Bubbled areas indicate revisions  
compared to the previously  
submitted plans

# 780 BLANSHARD - REHABILITATION + ADDITION

HAV00034 CONCURRENT WITH REZ00825

DATE	REV	ISSUE DESCRIPTION
2022-02-24	1	REZONING PRE-APPLICATION
2022-06-01	2	OPEN HOUSE PROGRESS SET
2022-06-21	3	REZONING APPLICATION
2023-03-23	4	HAP & REZONING RESUBMISSION

A000

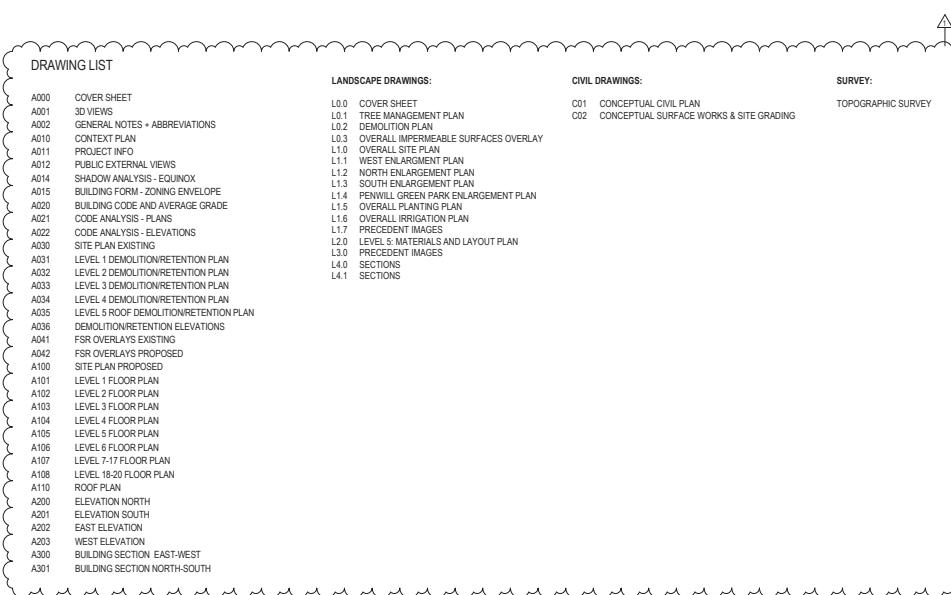
1 The submission drawings were expanded and reorganized to comprise a Razoring + HAP application per ARS comment. Design changes to the materials are bubbled and noted but, for clarity, organizational changes (like sheet-numbering) are not.

SHADOW ANALYSIS - EQUINOX

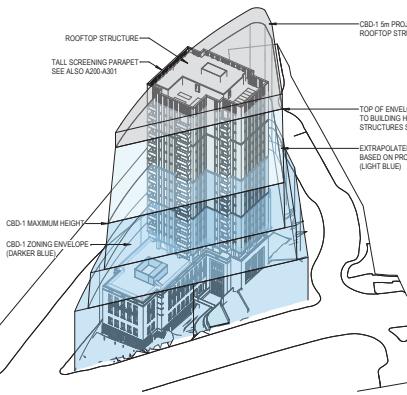
15. Shadow impacts per DCAP guidelines are included on this sheet to assist with the Submittal of a HAP. Original Submittal in the form of the Large Project Supplementary Information Booklet has also been updated.

1 Axonometric View of Overlaid CBD-1 + DCAP Setback Envelopes (East)

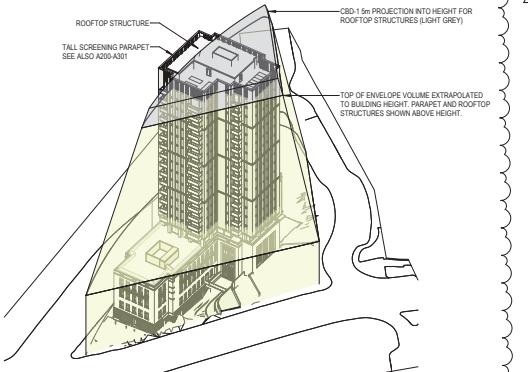
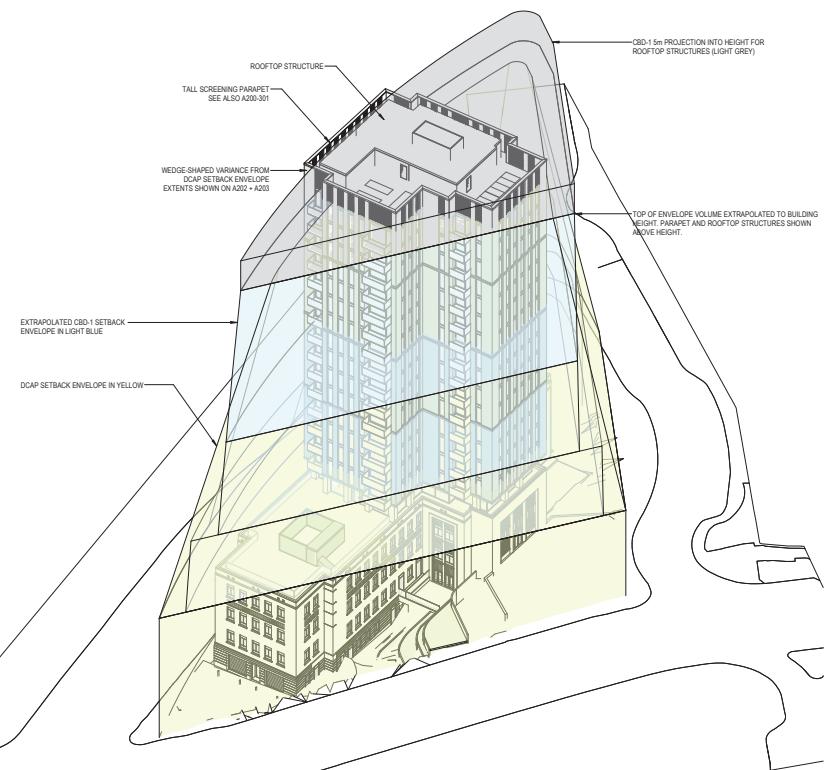
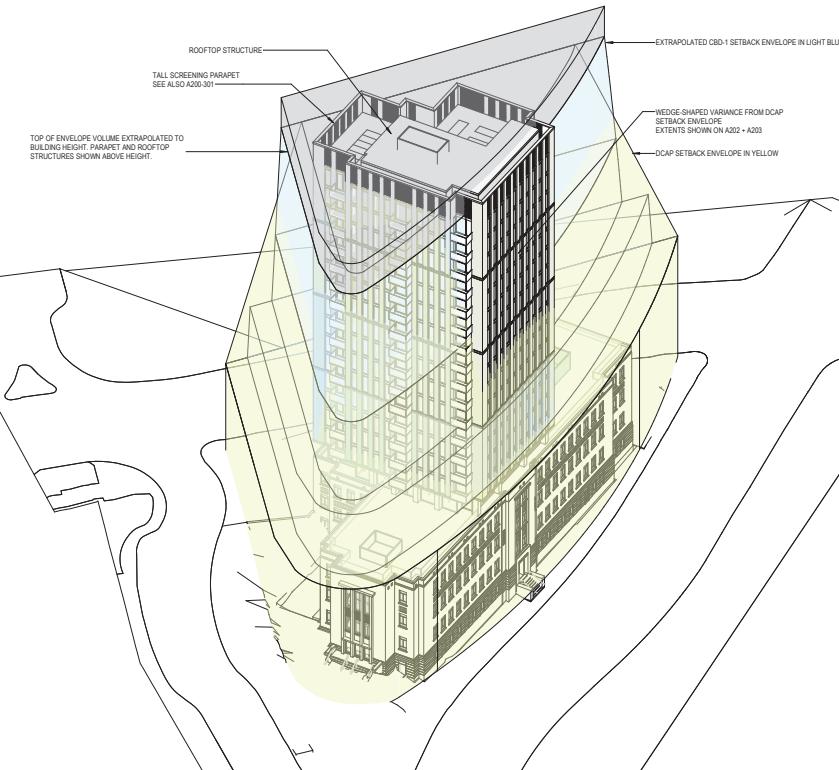
16 Zoning envelope diagrams updated with shorter revised massing developed in response to ARS Comment A22.

3 CONTEXT SECTION - SOUTH TO NORTH FACING WEST

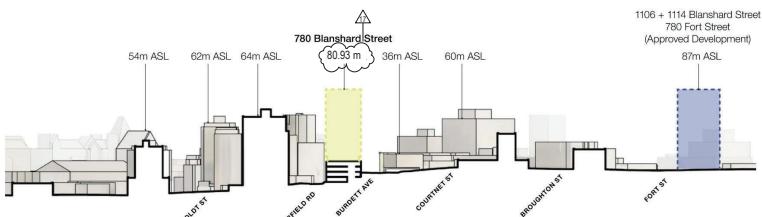
17 Updated Height per ARS comment #22

#### DEMOLITION/RETENTION ELEVATIONS

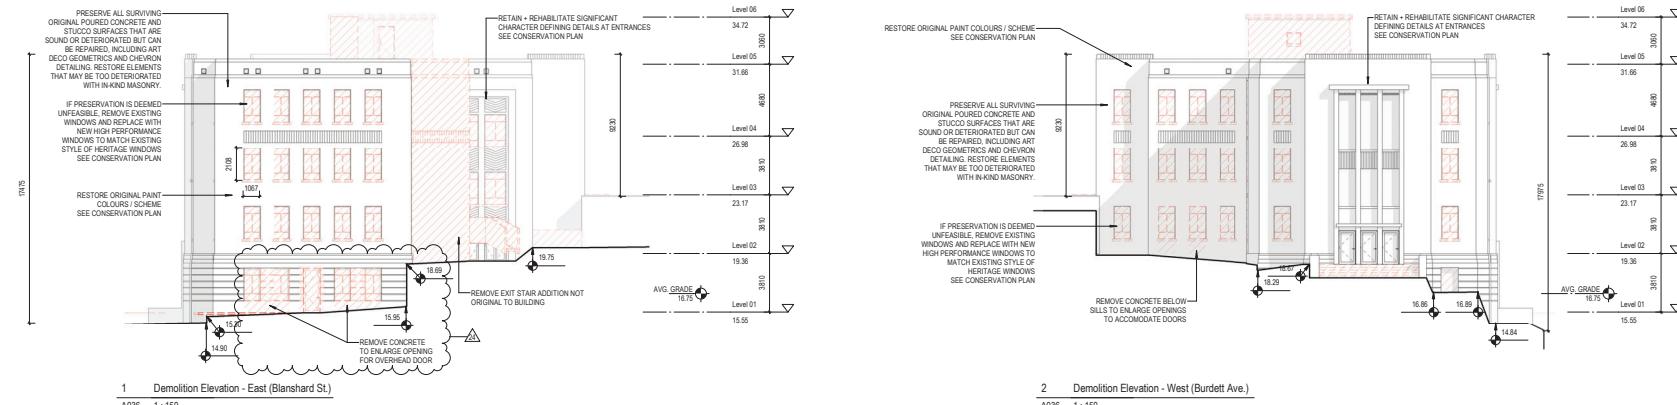
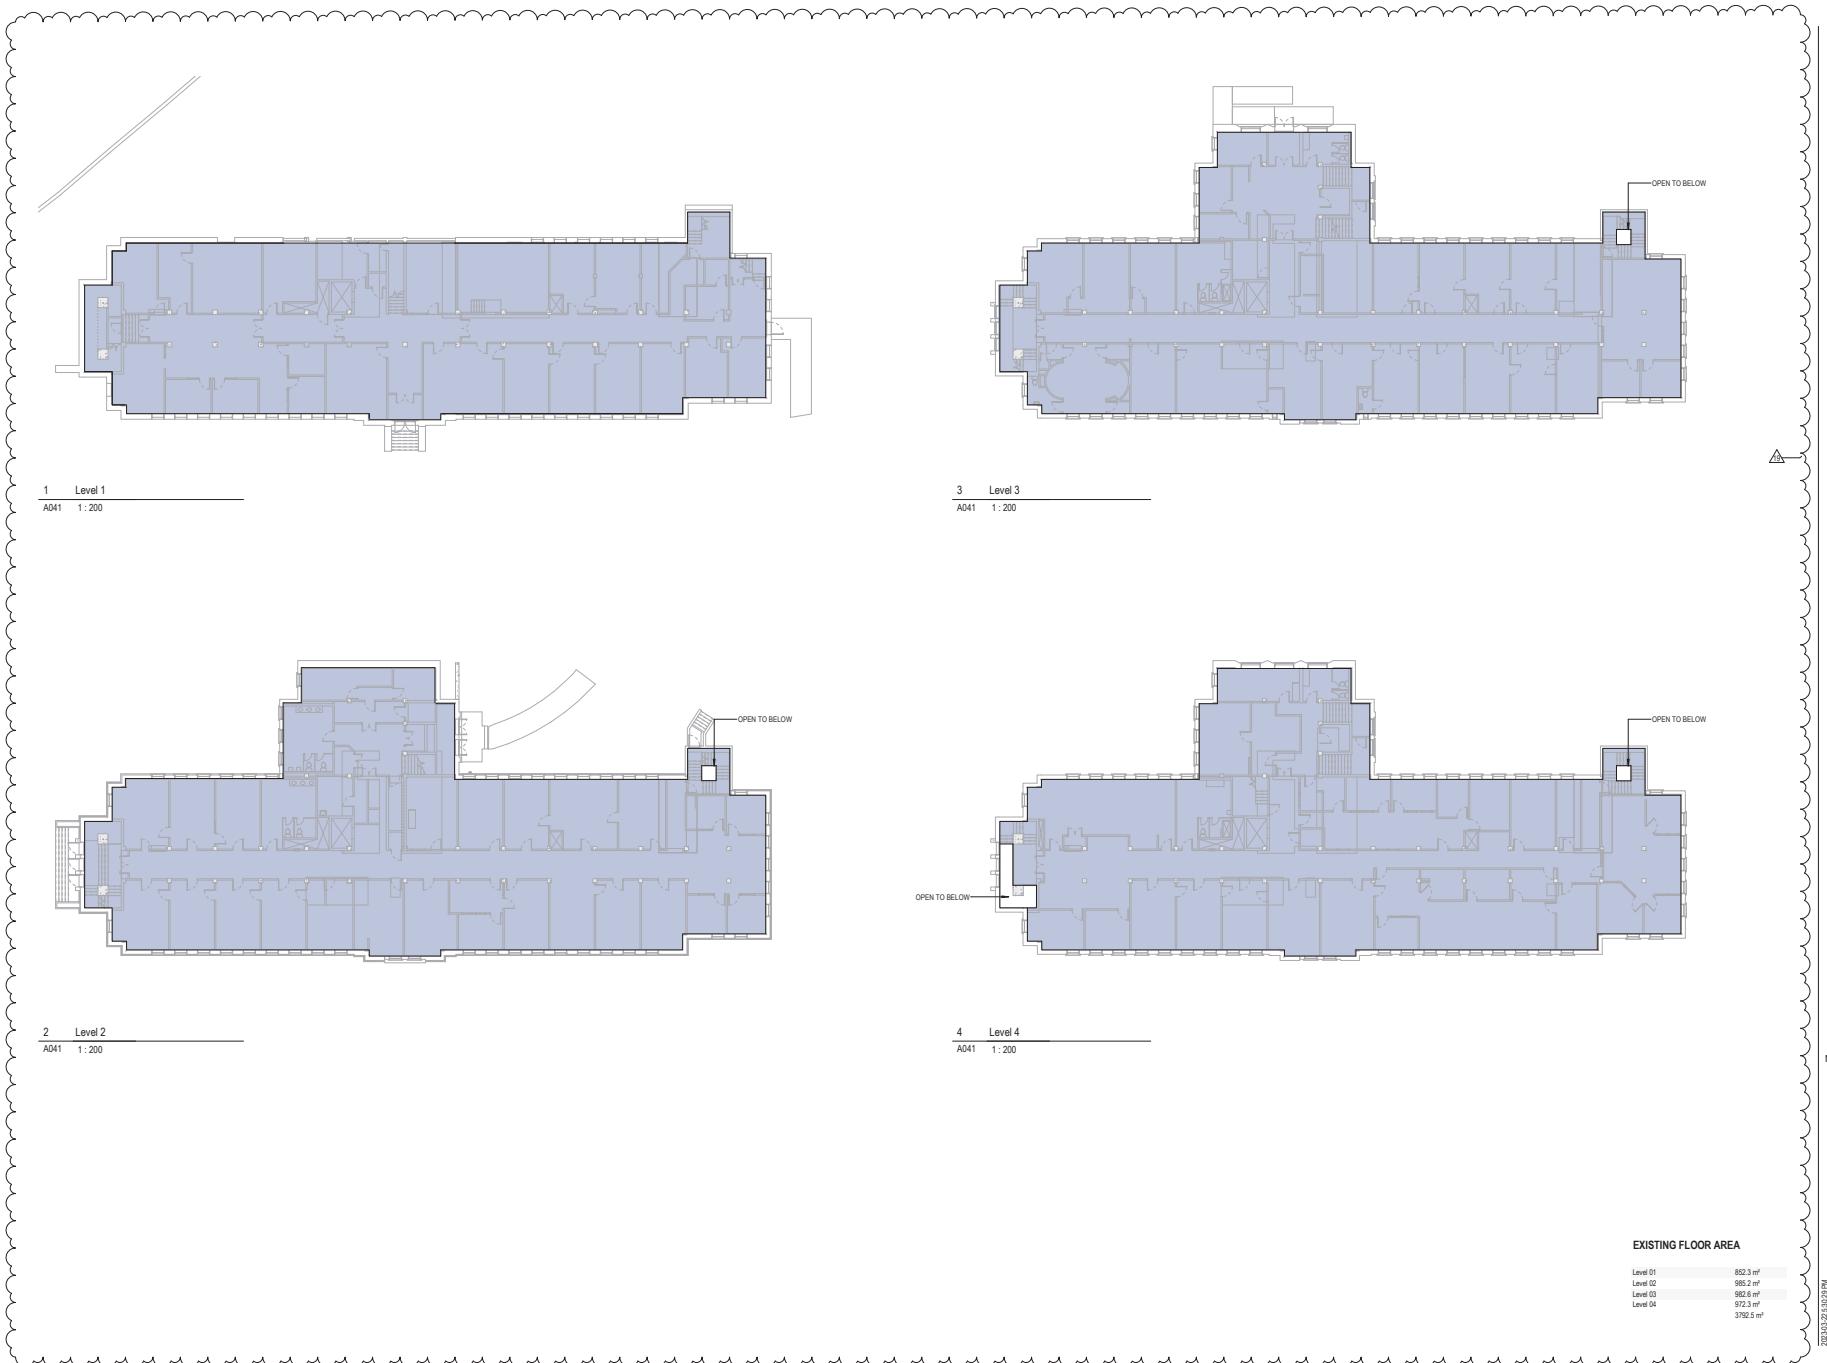
21 To address ARS Comments #11a and #11b, additional information including revised demolition drawings, revised site plan, revised features, updated conservation plan, and heritage impact assessment. See also heritage submission materials from Community Design Services.

24 Extent of concrete demolition modified to reflect planning updates from interior design development and as a result of massing changes from ARS Comment #22.

#### LEVEL 1 FLOOR PLAN

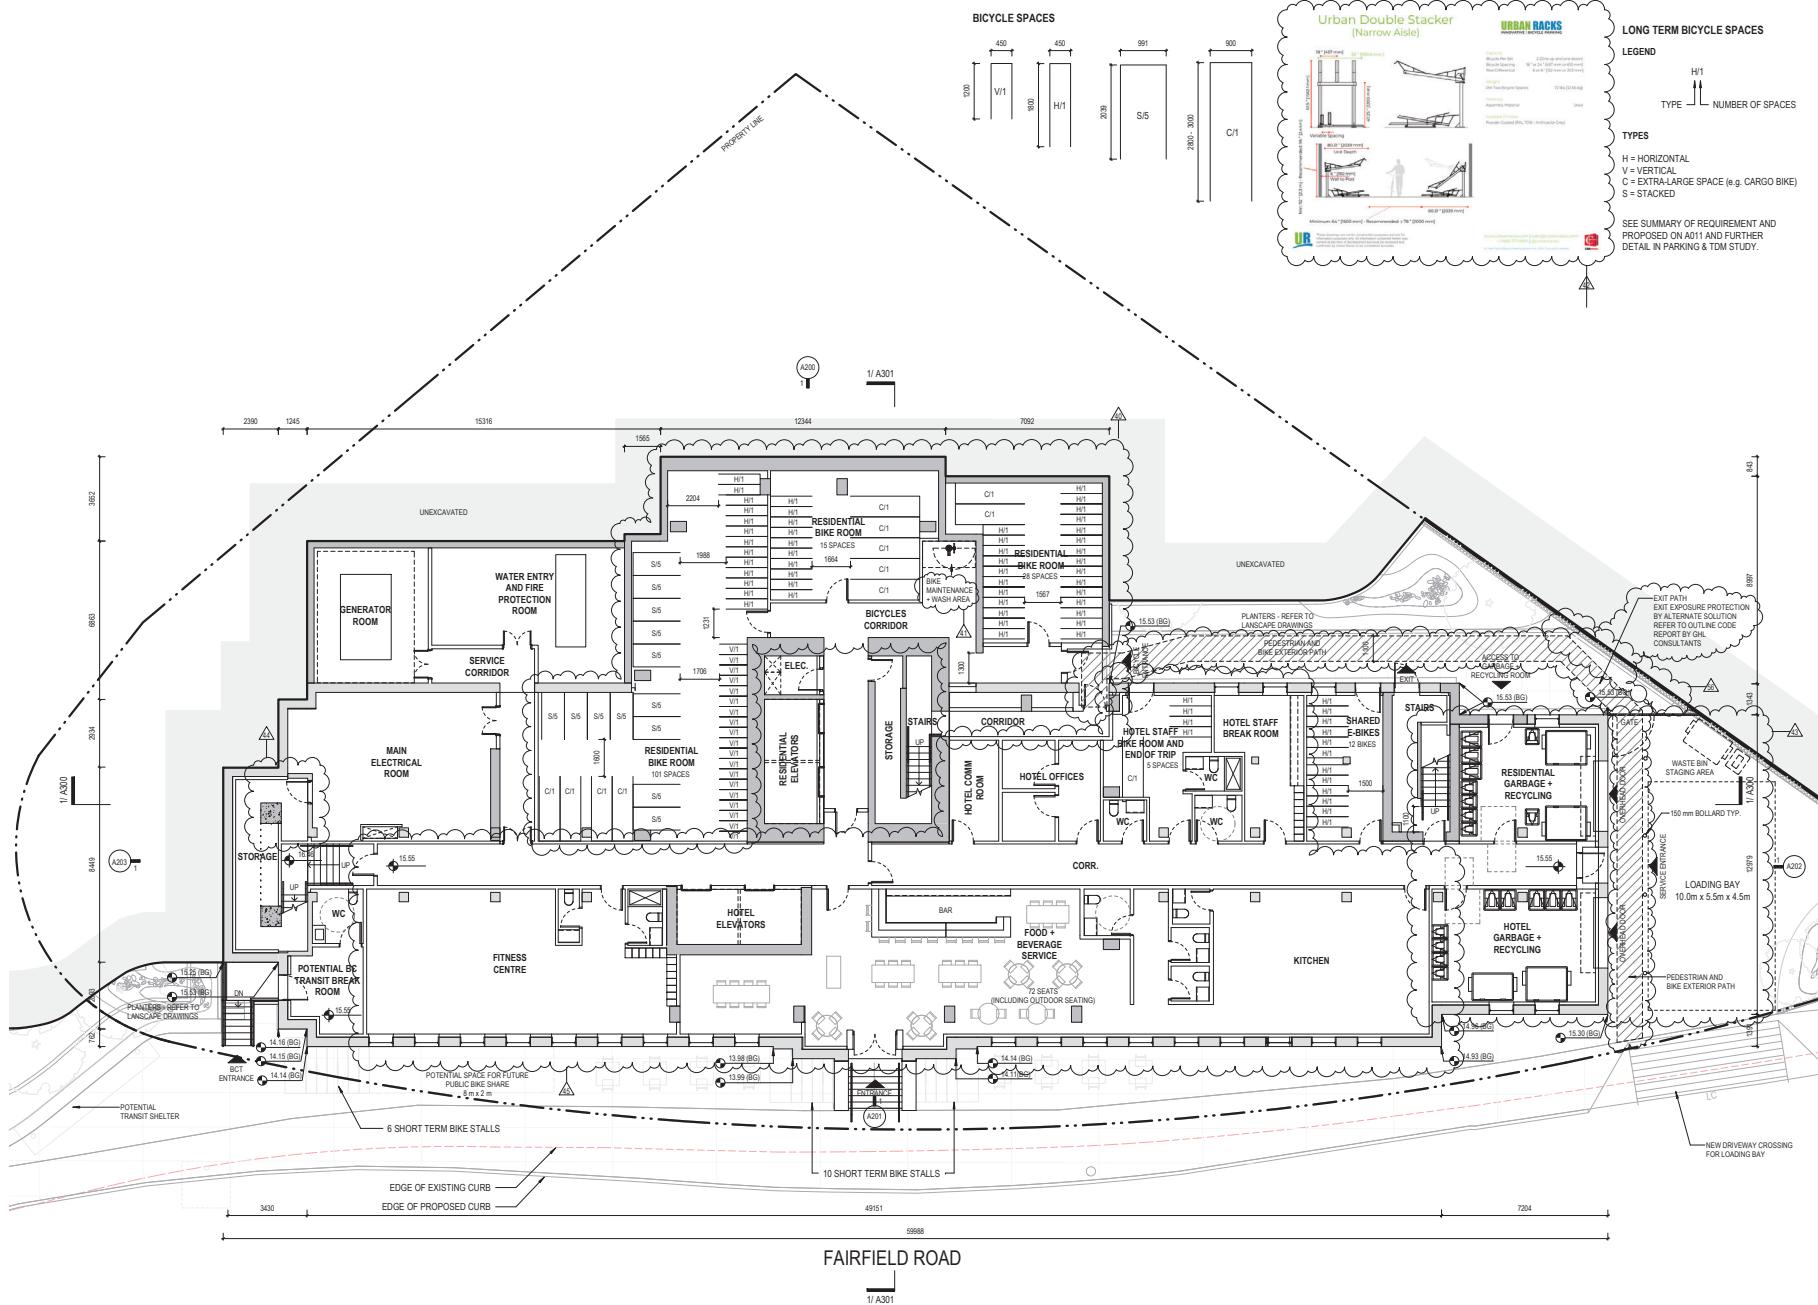
- 40 Bicycle parking provision and layout updated to confirm basis of design and to align with revised requirements for the number and type of horizontal ground-level stalls per ARS Comment #39.

- 41 Bike wash area included per ARS Comment #52.
- 42 Basis of design info for stacked bicycle storage in response to ARS Comment #53.
- 43 Residential and hotel waste and recycling rooms consolidated along the rear of the building. Residential waste and recycling shown to separate vehicles from pedestrian and bike areas. Bin storage to be performed away from path of travel. See Response Letter for additional details on the revised waste and recycling room layout.

- 44 Existing storage room no longer exists due to an in response to ARS Comment #116.
- 45 Hotel planning, including room count, revised based on further design development, HAP and changes to massing resulting from revised design. See Response Letter.

- 56 In response to ARS Comment #38, a new retaining structure is proposed inside of existing retaining wall where new grade is lower than existing. See also Response Letter for Geotechnical and Structural feedback and Landscape changes for new earth.

LEVEL 18-20 FLOOR PLAN

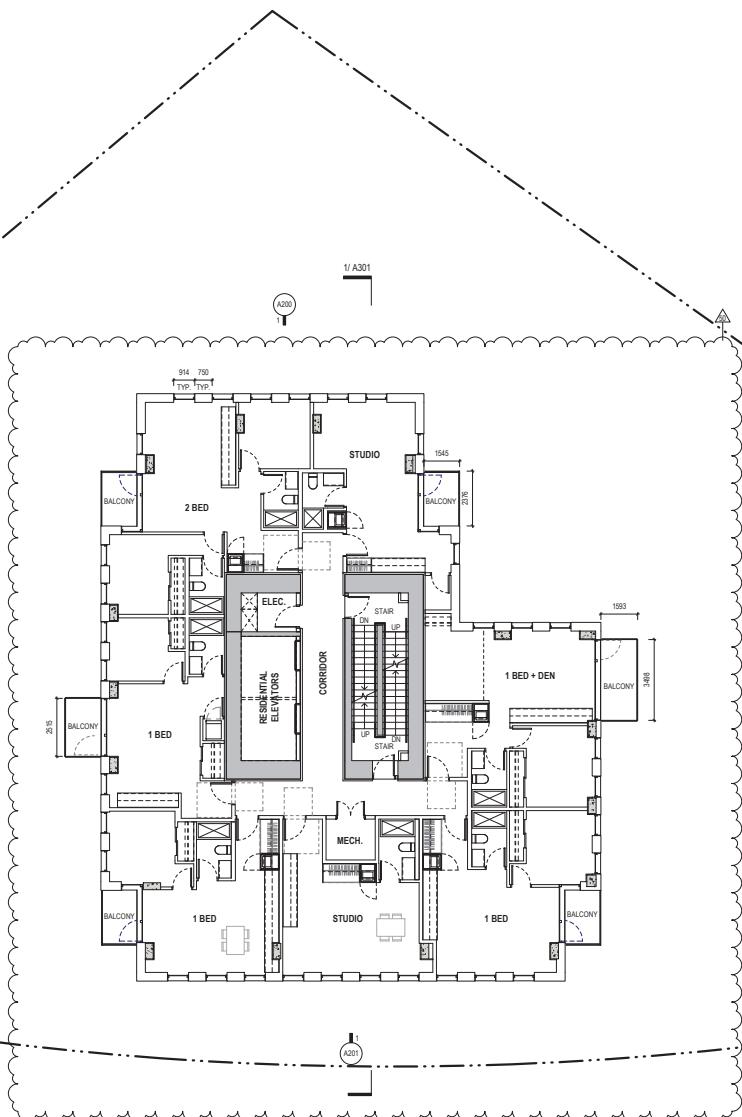
50 Residential tower floor plate design and suite mix revised to suit 780 Blanshard Street. Suite mix revised to suit suites #421, #422, and #424. See also Response Letter and Sections 10 and 11 in Large Project Supplementary Information Booklet.

MECHANICAL ROOFTOP PLAN

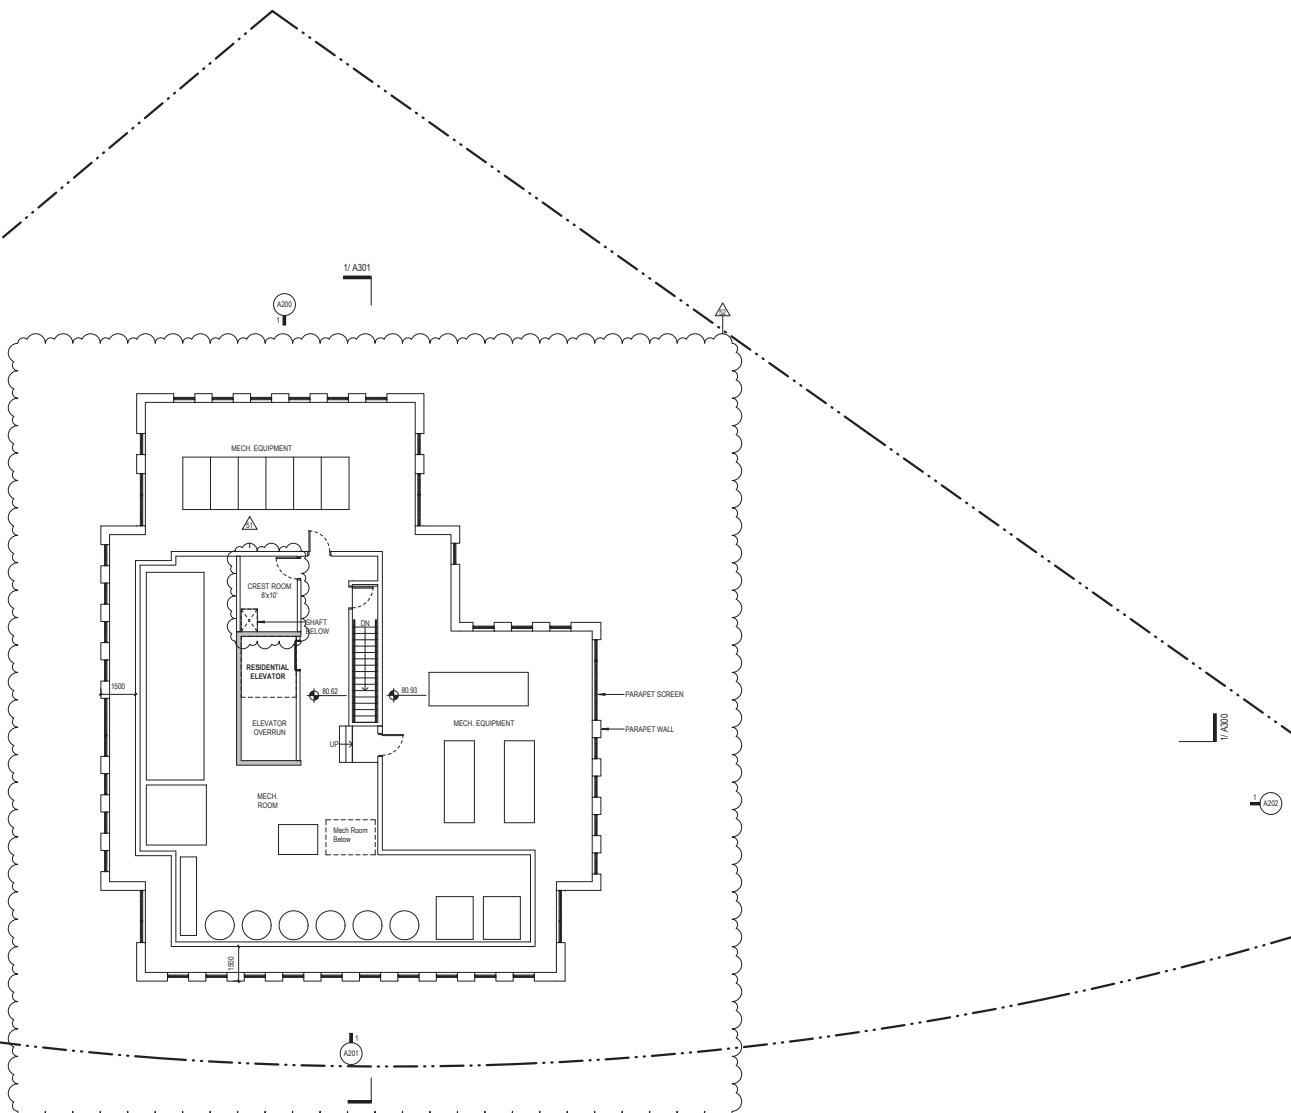
S1 Secured equipment room for CREST in response to ARS Comment #425  
S2 Roof top design shows revised mechanical room and equipment to suit revised masking and tall parapet all around to respond to ARS Comment #425
